Project Name: **Change of use to Intermodal Transportation Facility for up to 30 vehicles**
Project ID: #2014-112 CBL: 10 H005001
Address: 122 Anderson Street, Portland
Applicant: Douglas Cardente, Anderson Street Realty LLC
Planner: Jean Fraser

**122 Anderson Street
Proposed Intermodal Facility for truck staging to load Nova Star Ferry
Level II Site Plan Review
#2014-112**

REPORT OF FINDINGS

DIRECTIONS TO THE INTERMODAL TRUCK STAGING YARD:

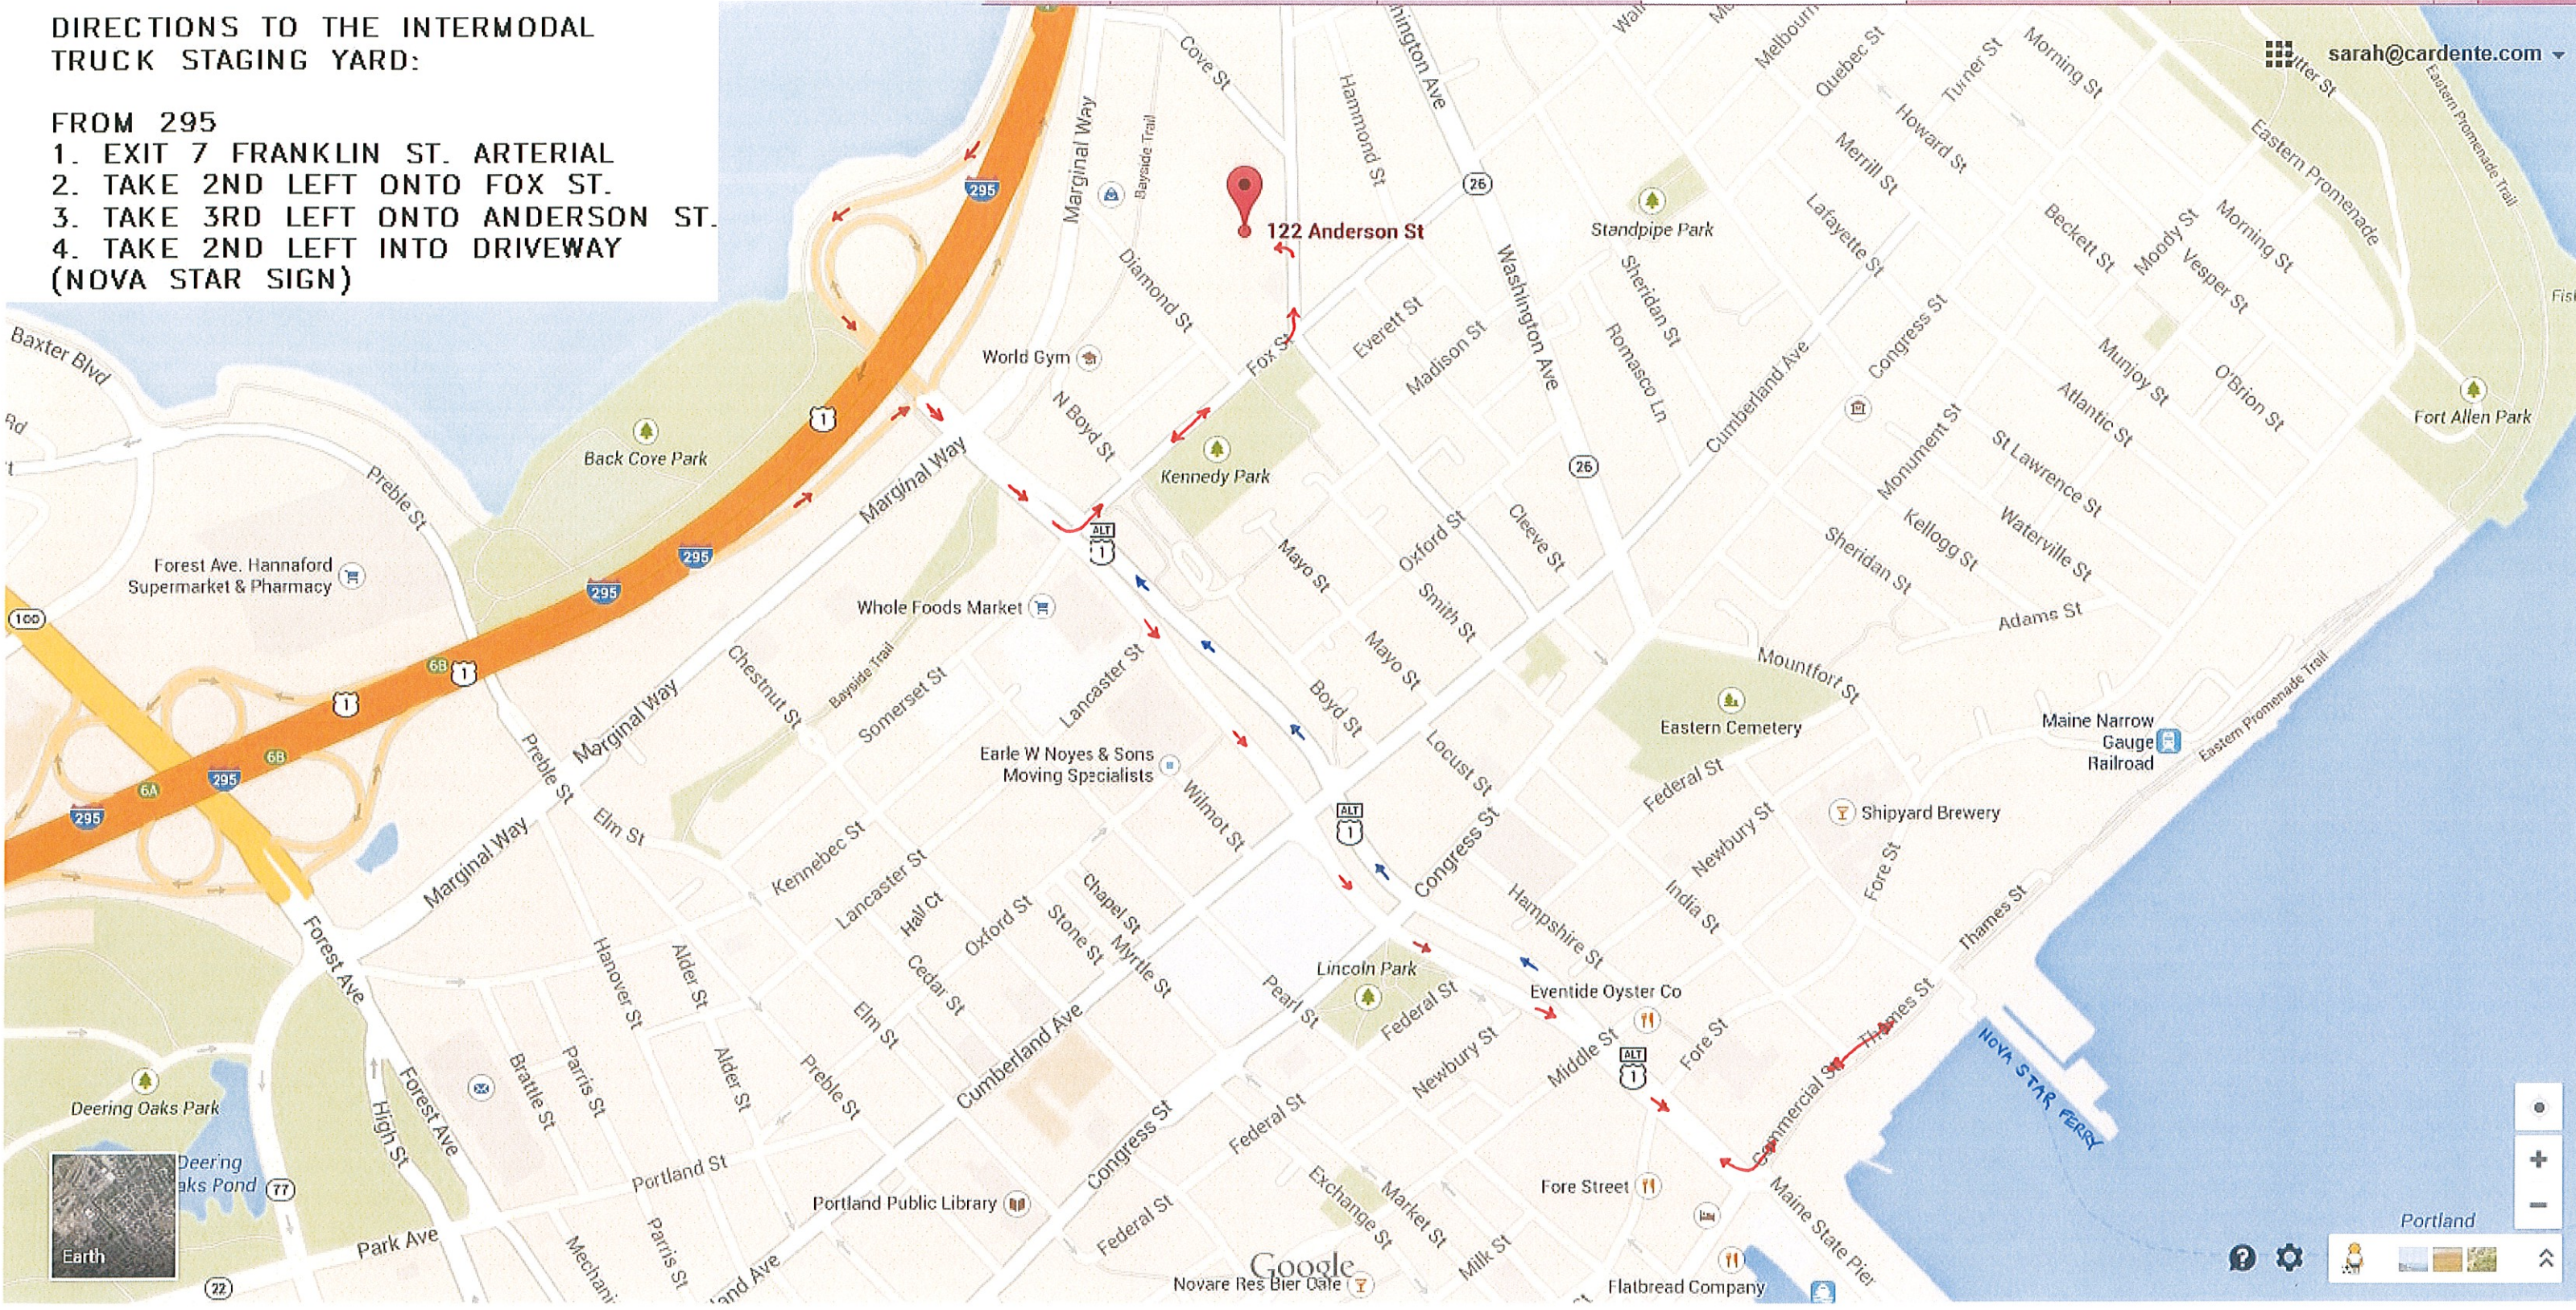
- * The applicant has suggested a routing plan from 122 Anderson Street to Fox Street and Franklin Street. I find this routing to be reasonable given the driveway geometric alignment (left-turn exit movements and right-turn entry movements would be problematic). Accordingly, the following recommendations are based upon this routing.
